| # | Question | Answer |

I understand in the ITT that all clarifications should be submitted at once so we preparing that. But when plotting the route from the RPL; There is a segment which looks a bit different.

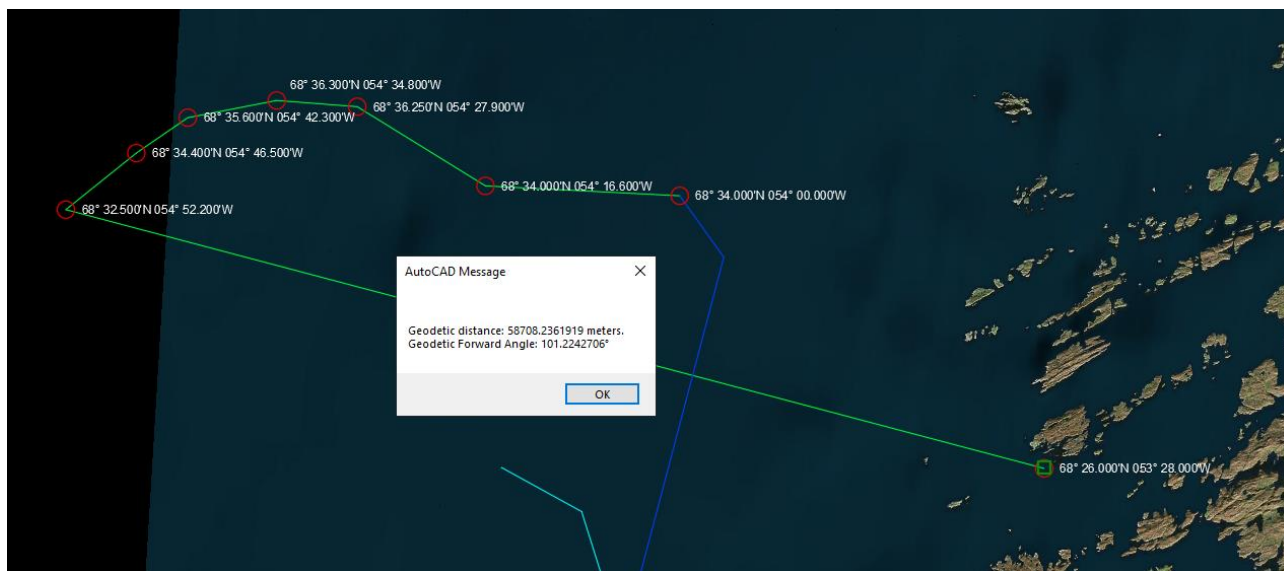
Segmentet distance (58,696 km grid, 58708 km geodetic) correct within ~300 m,
So our RPL read have been correct. And the route makes a jump in 1 in long

| # | Question | Answer |
|----|---|--|
| 14 | Please confirm this is correct | The typo in the RPL has been corrected. KML-file is correct. |
